TVA-BFN-TS-424

BROWNS FERRY NUCLEAR PLANT (BFN) - UNITS 1, 2 AND 3 - LICENSE AMENDMENTS AND TECHNICAL SPECIFICATION CHANGES - REVISION IN THE NUMBER OF EMERGENCY CORE COOLING SYSTEMS REQUIRED IN RESPONSE TO A LOSS OF COOLANT ACCIDENT (TS-424)

License Amendments and Technical Specification Changes - Revision in the Number of Emergency Core Cooling System Subsystems Required in Response to a Loss of Coolant Accident (TS-424)

Simplified diagrams showing the current (Figures 1-3) and subsequent (Figure 4) ECCS initiation logic are shown below:

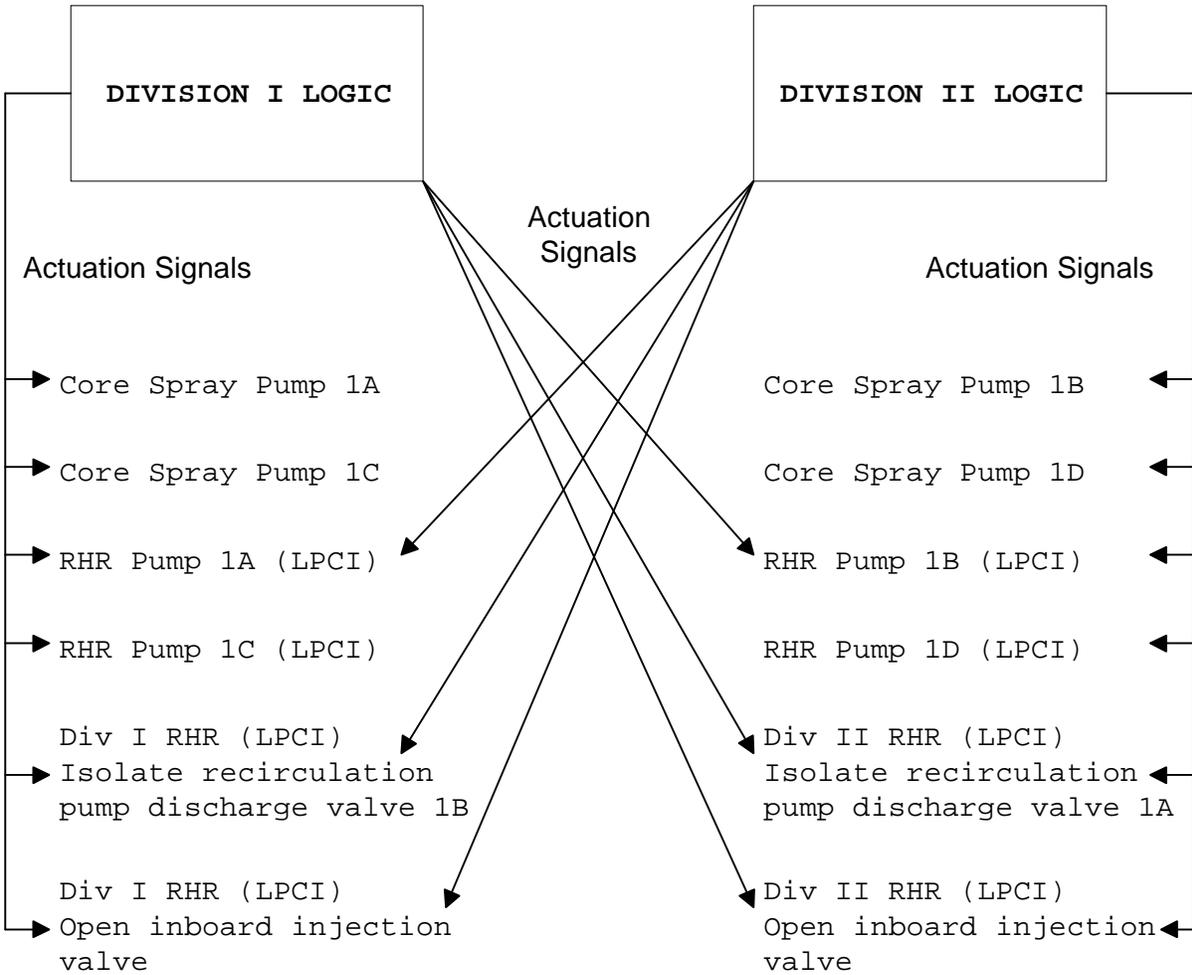
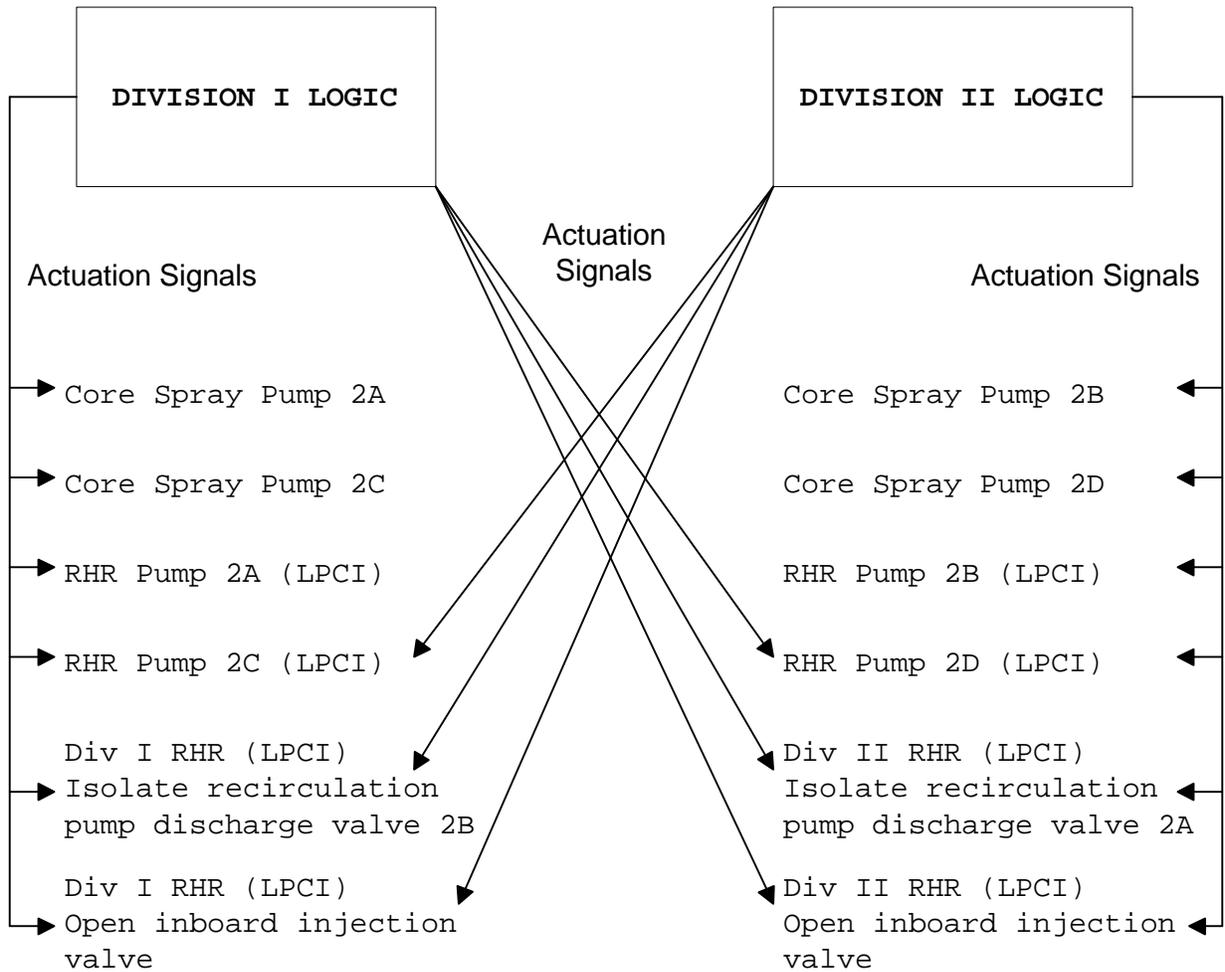
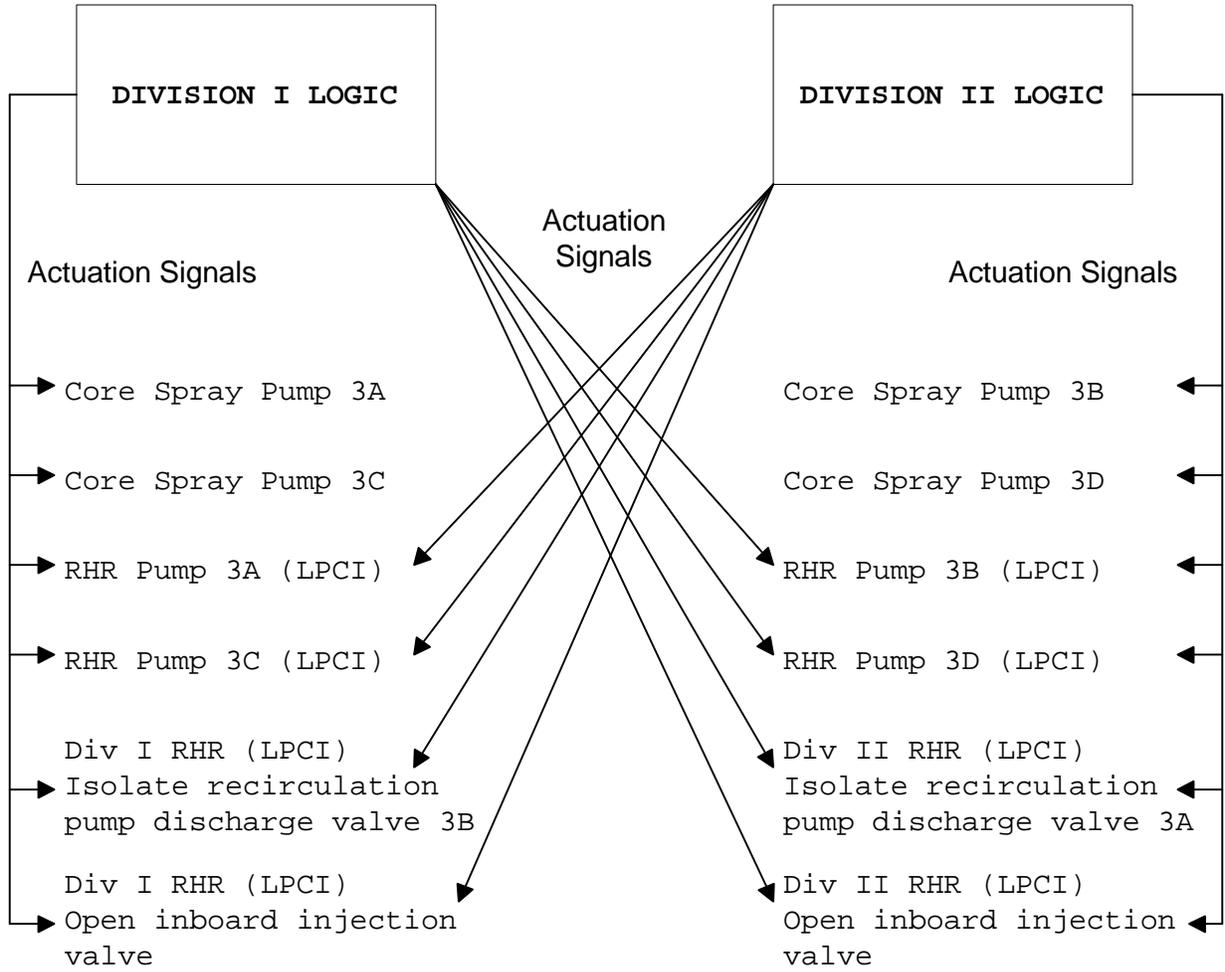
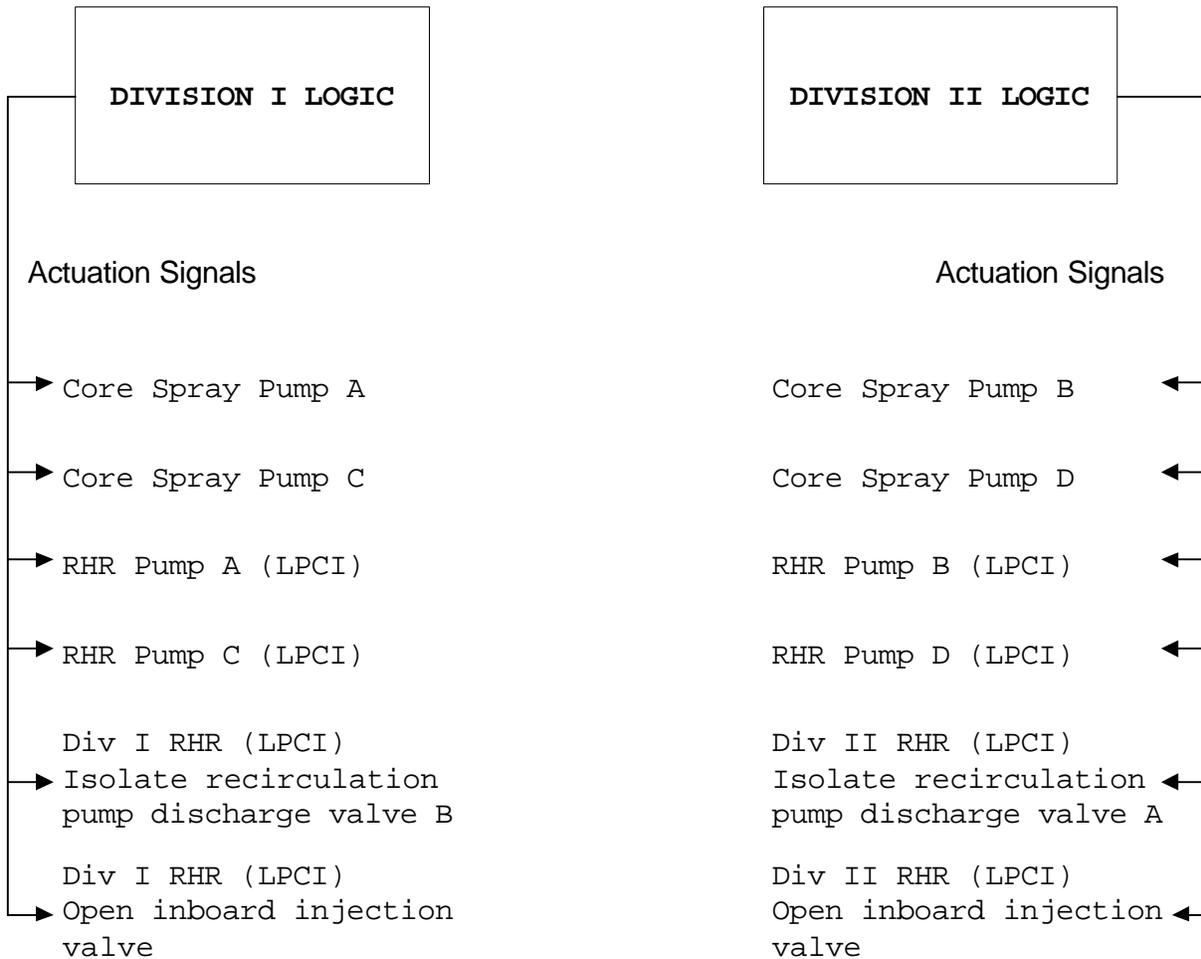
The current Units 1, 2 and 3 ECCS initiation logic sends a start signal to one or more RHR pumps in the opposite division to ensure that at least one pump is operating in each LPCI loop following a LOCA. The opposite division's RHR (LPCI) pump start signal, including the associated pump start time delay relay, will be deleted. The ECCS initiation logic will be modified so that the Division I RHR initiation logic will only start the Division I RHR pumps (A and C). The Division II RHR initiation logic will only start the Division II RHR pumps (B and D).

Because the start of the opposite division's RHR pump is being deleted, the cross-divisional signals for closure of the opposite LPCI loop's recirculation pump's discharge valve or opening of the LPCI injection valve are no longer required. Therefore, the ECCS initiation logic will be modified so that the Division I signal will only close the B recirculation pump discharge valve and open the Division I inboard injection valve, while the Division II signal will only close the A recirculation pump discharge valve and open the Division II inboard injection valve.
